INNER WEST COUNCIL

DEVELOPMENT ASSESSMENT REPORT

| Application No. | D/2018/58 |
| Address | 109 Birchgrove Road, BIRCHGROVE NSW 2041 |

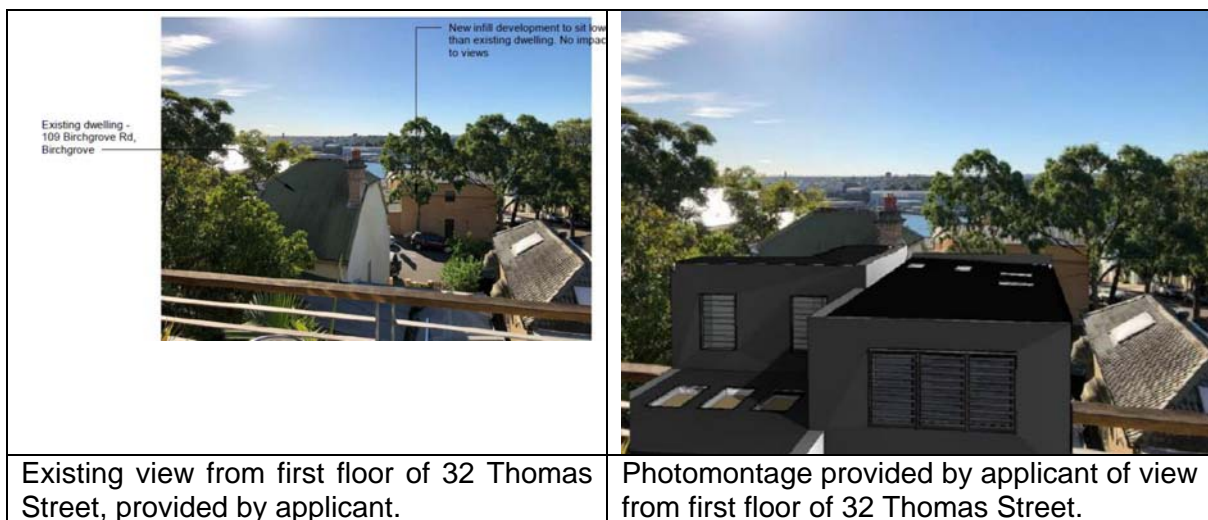
Views as defined above, are not considered to be obtained from 30 Thomas Street, in the photographs submitted. See below for photos submitted from first floor of 30 Thomas Street:

NO. 32 THOMAS STREET
- EXISTING VIEW FROM FIRST FLOOR

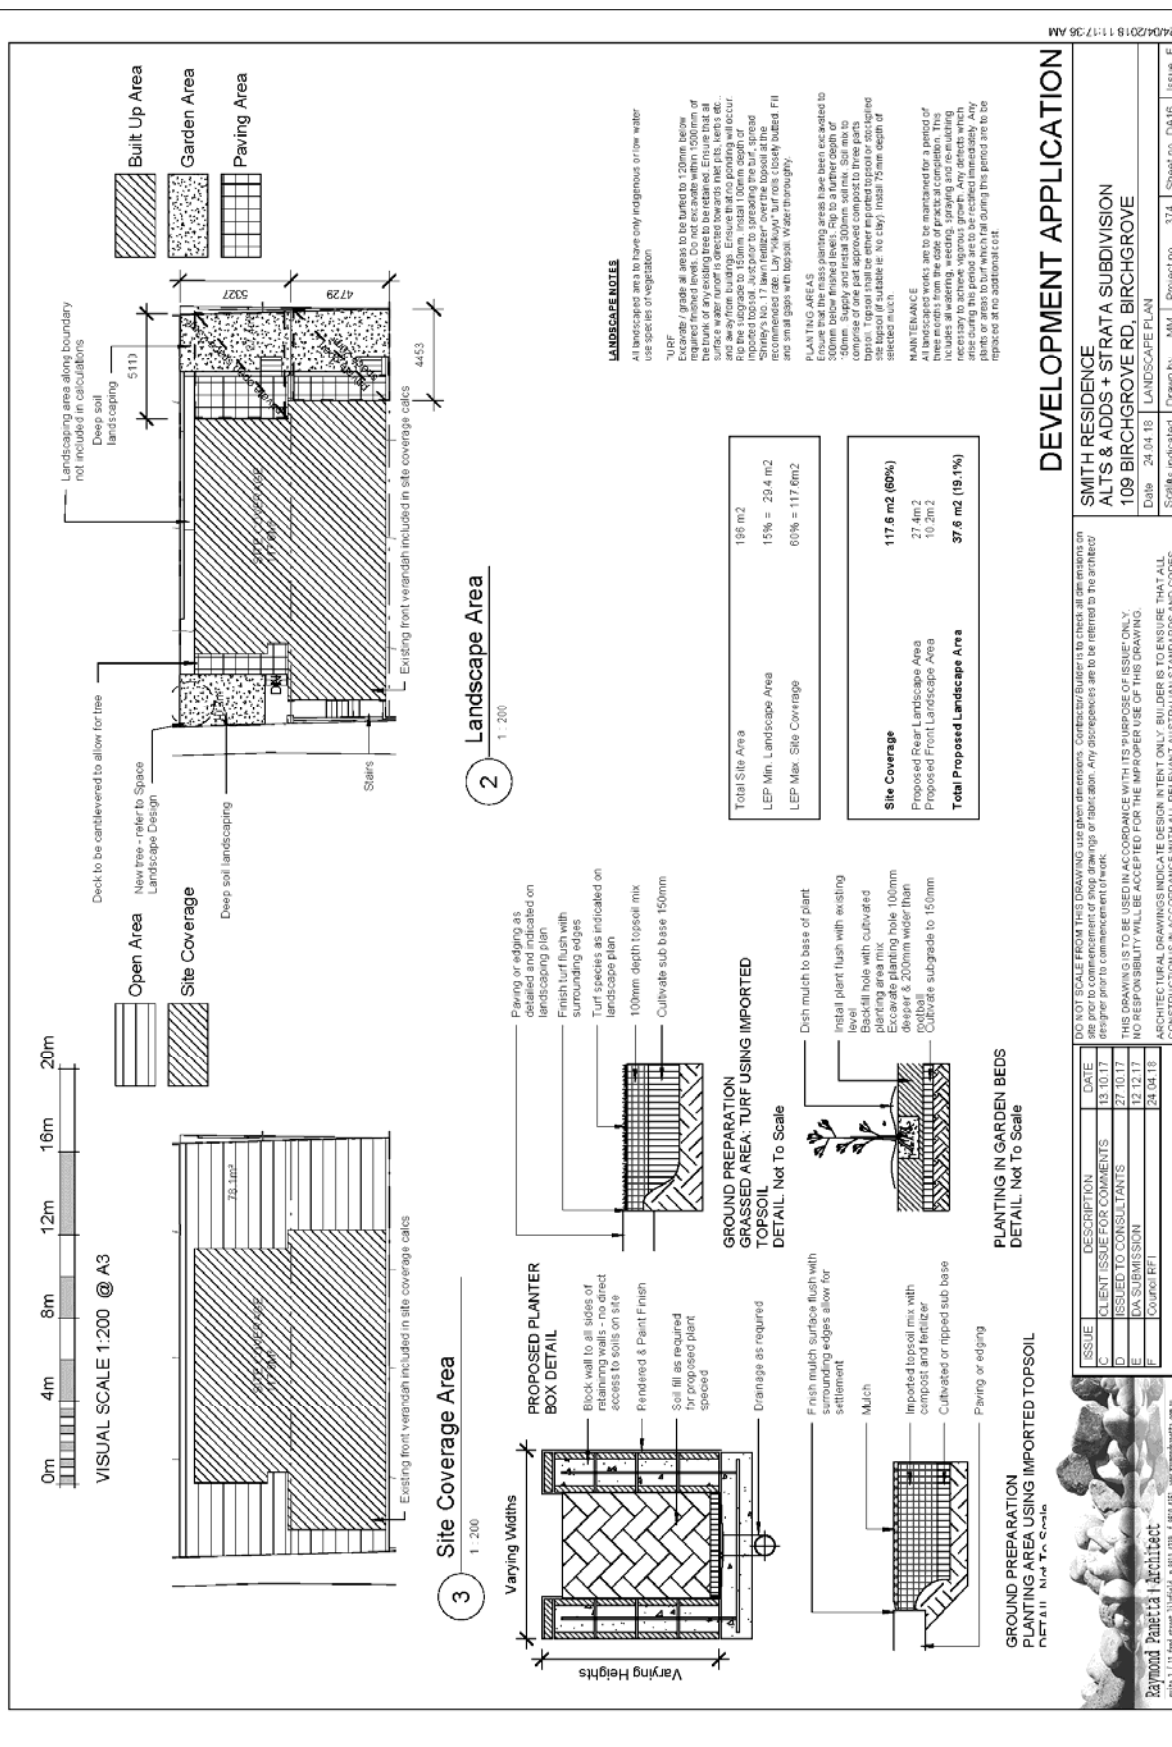
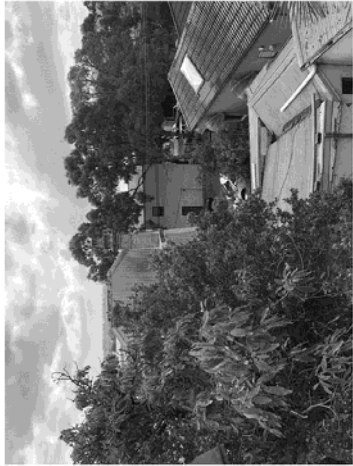
An assessment of the views available from 32 Thomas Street in the steps outlined in the planning principle established by Tenacity follows:

Ground floor: Water views and views of the land/water interface are currently available from the kitchen and rear yard of 32 Thomas Street (see below).
